June 28, 2018

**Re: Hydrogeological Reevaluation Report
Spinner Road Crossing (S2-0080)
Permit No. E11-352
Munster Township, Cambria County**

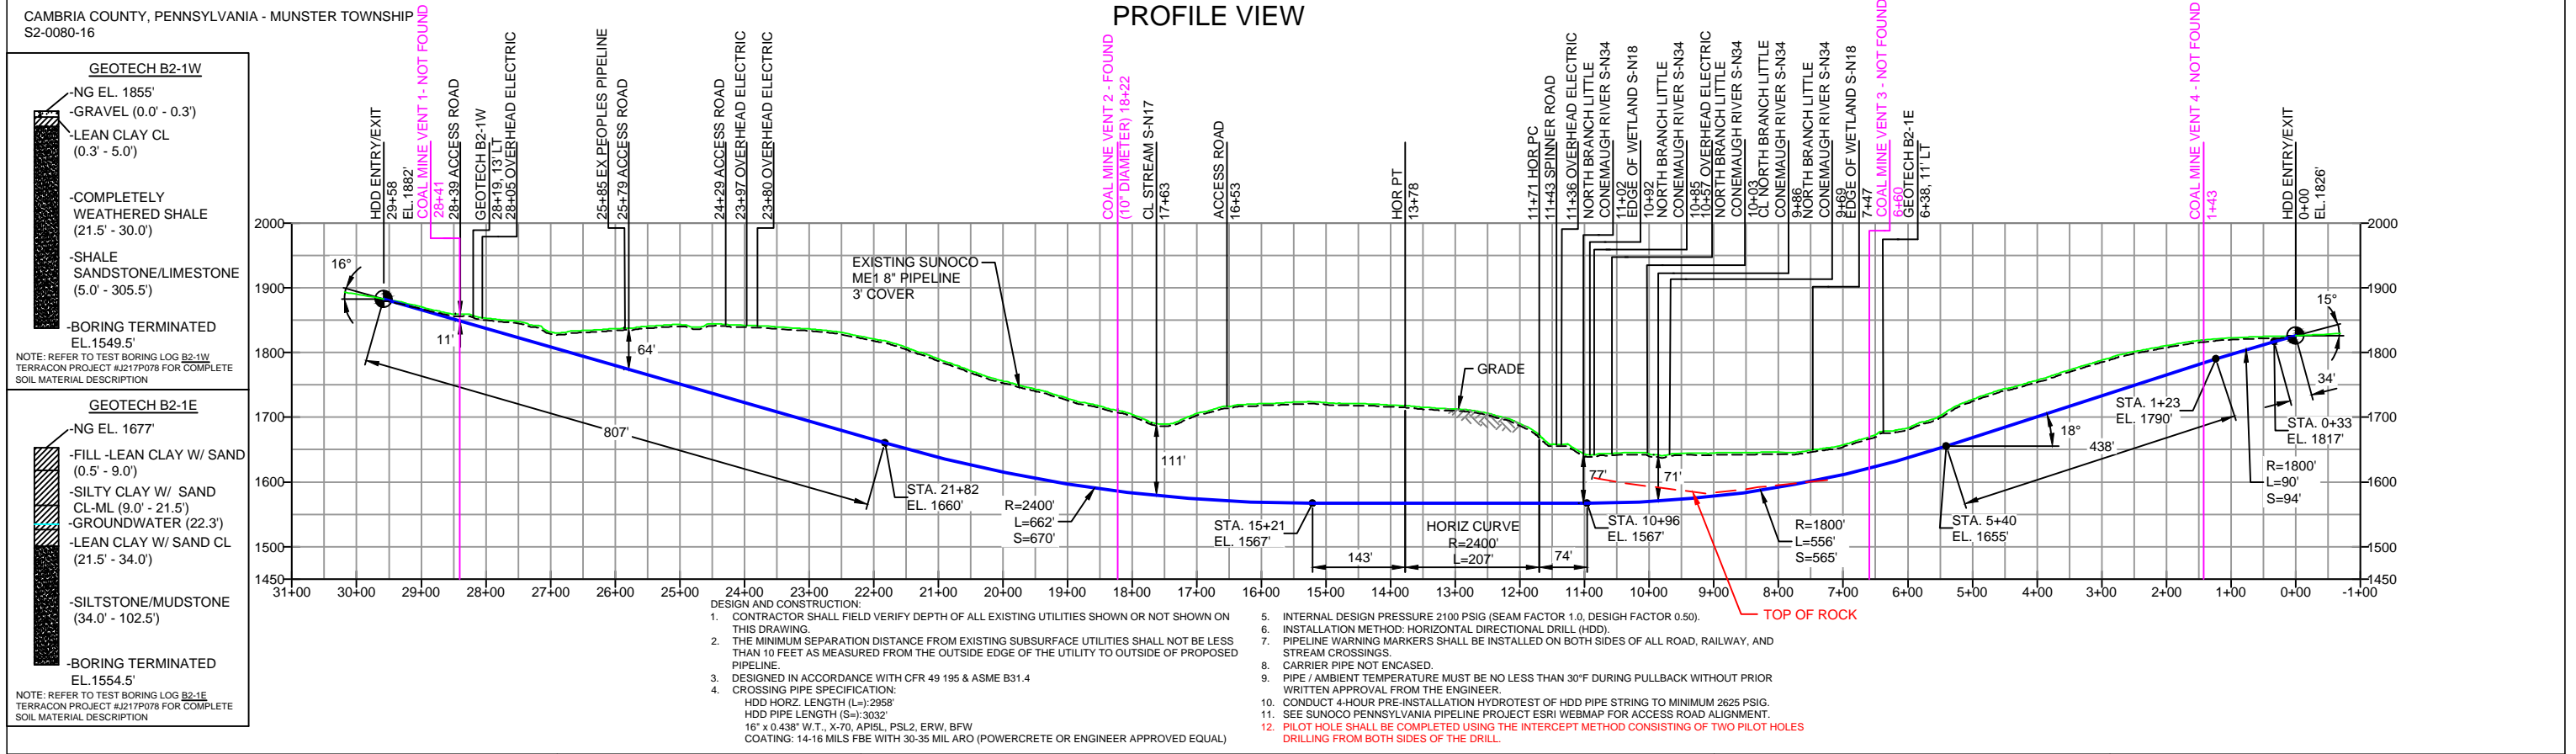
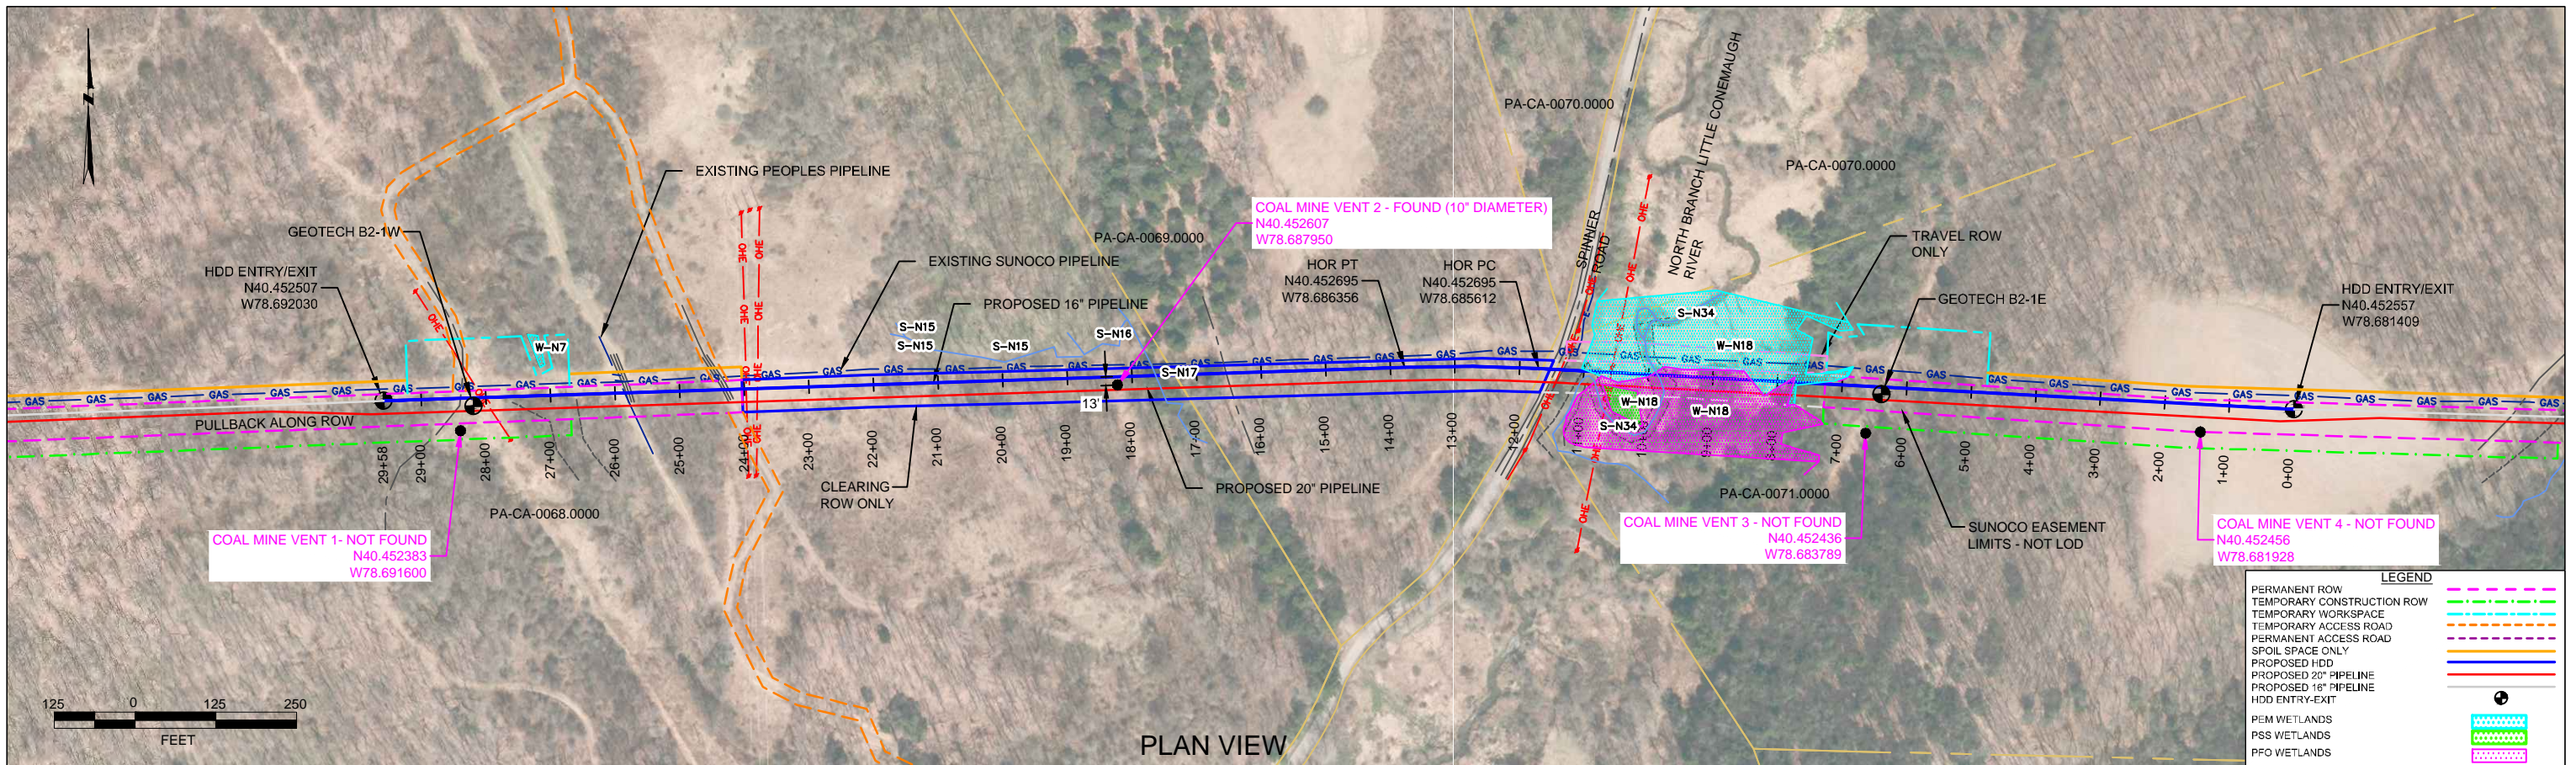
4. Please show the location of the Mariner East 1 pipeline on the profiles.

The HDD plan and profiles provided with the Reevaluation Report show the location of the Mariner East 1 pipeline in the "plan view" as being north of and parallel to the planned 20-inch and 16-inch pipeline installations. This pipeline was installed by conventional construction methods, and at the scale of the HDD plan and profiles cannot be shown with accuracy in the profile view. Regardless, a mock representation of the Mariner East 1 pipeline has been added to these profiles and is included with the amended Reevaluation package.

REF. DRAWING		REVISIONS	
ES-2.47	TO ES-2.48	EP8	ADDED ME1 PIPELINE AND TOP OF ROCK AT STATION 12+00 PER DEP COMMENTS
SHEET 29	TO SHEET 30	EP7	UPDATED NOTE 5 AND 10 PER INCREASED 16" MOP
		EP6	ADDED COAL MINE VENT LOCATIONS
		EP5	UPDATED GEOTECH BORE ELEVATION INFO PROVIDED BY DPS
		EP4	UPDATED GEOTECH INFO PROVIDED BY DPS
		EP3	RELOCATED HDD ENTRY / EXIT POINTS - DESIGN CHANGE BY DPS
DWG NO	DWG NO	NO.	DESCRIPTION

Figure 1. Original 20-Inch HDD Plan and Profile

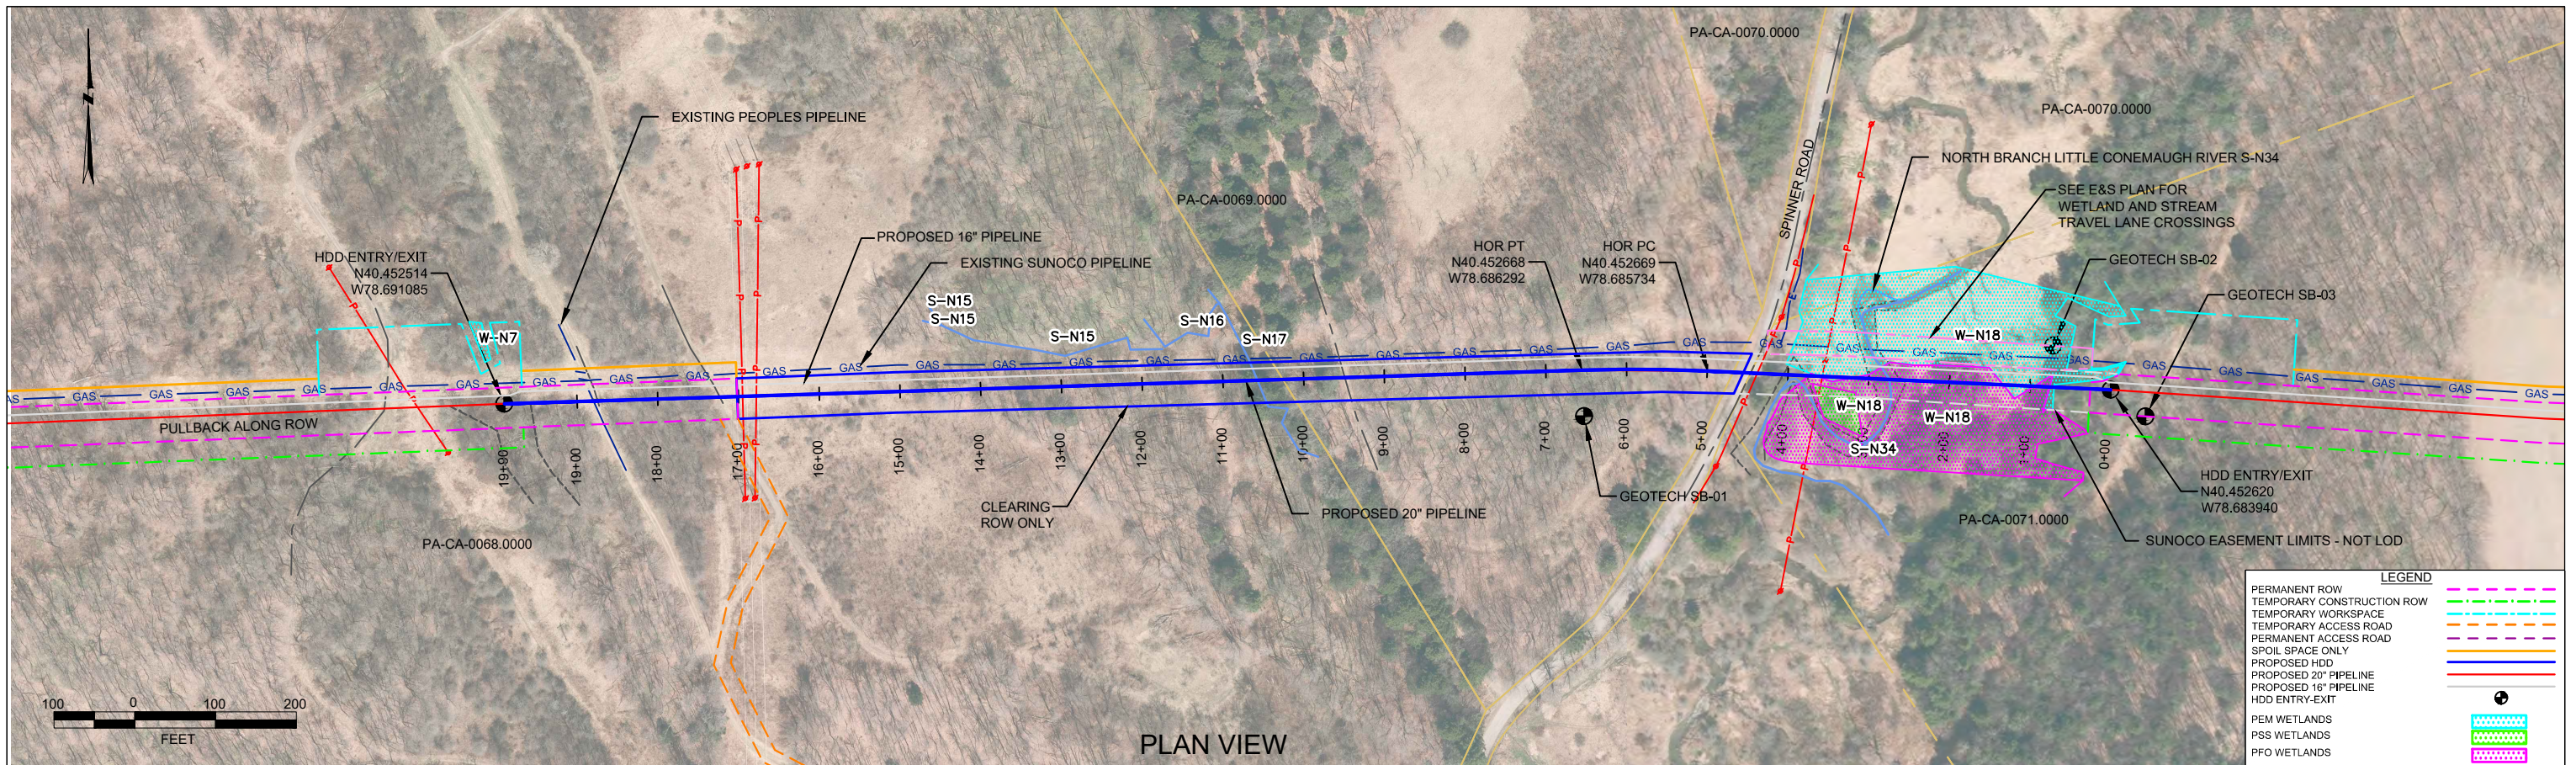
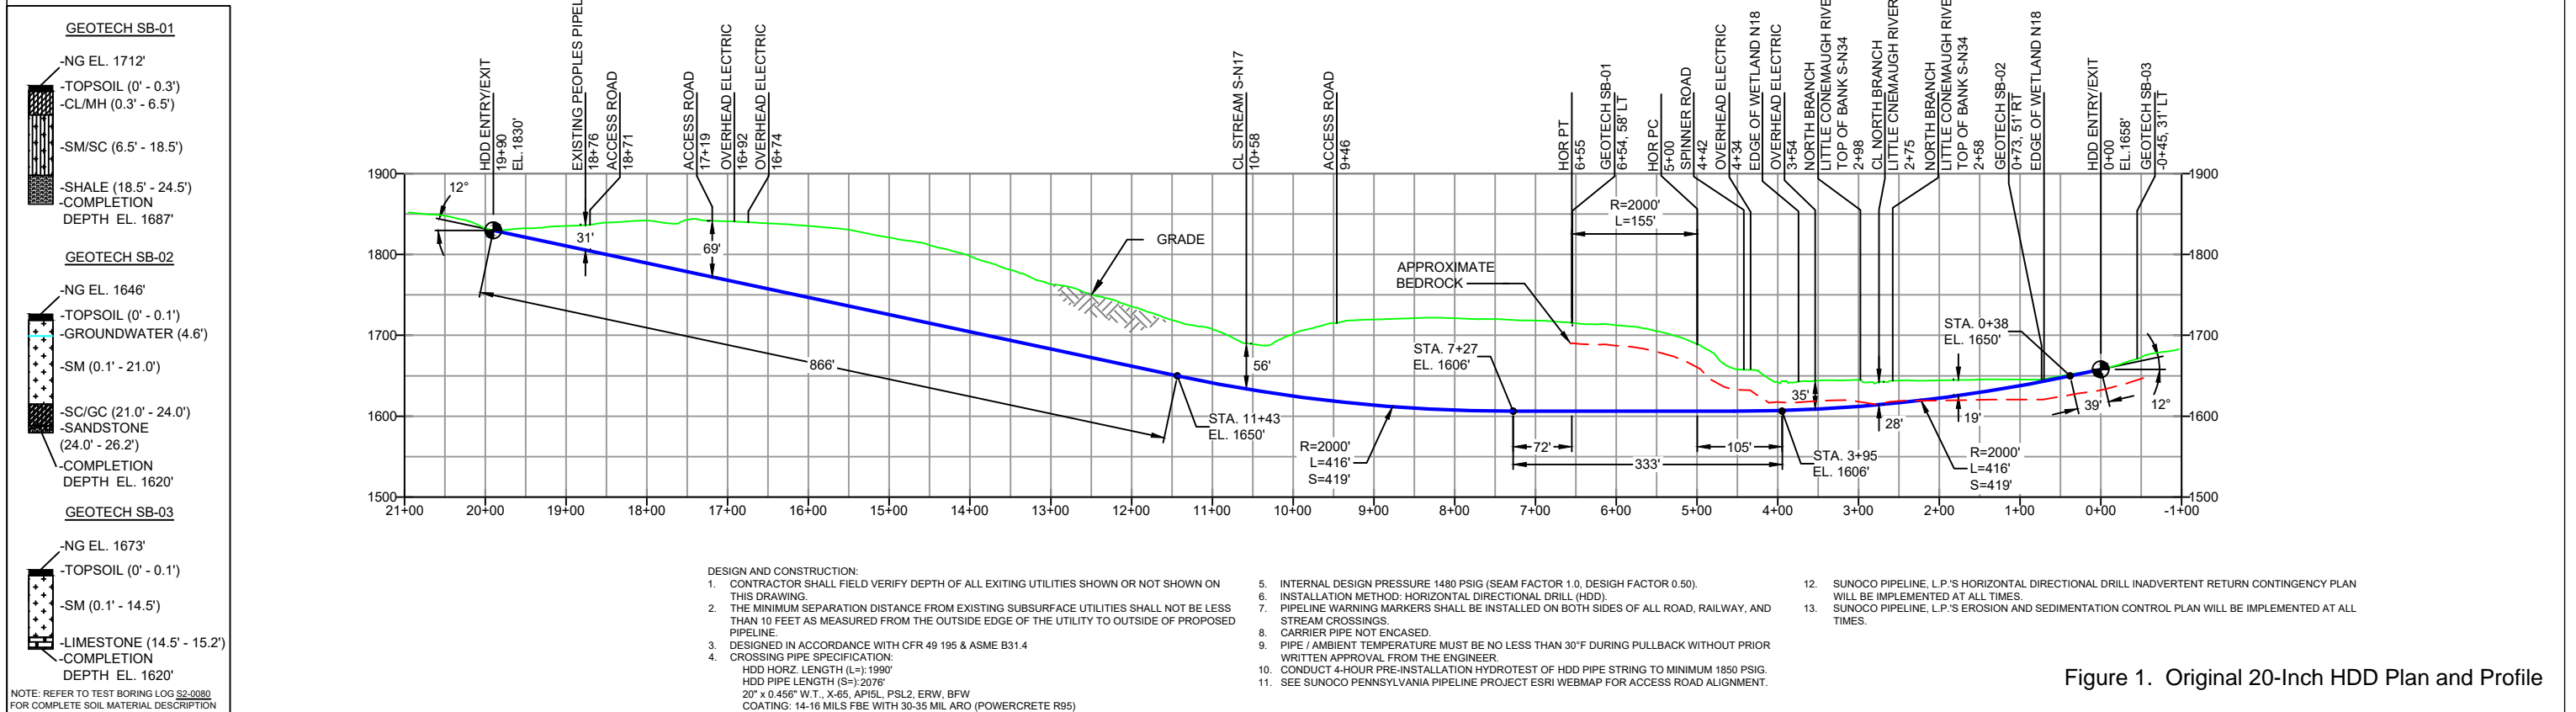
It is SPLP's intent to modify the original profile design and to pursue a deeper and longer HDD profile. Figure 1 and 3 in Attachment 4 presents the original HDD plan and profiles. Figure 2 and 4 present the revised HDD plan and profiles.
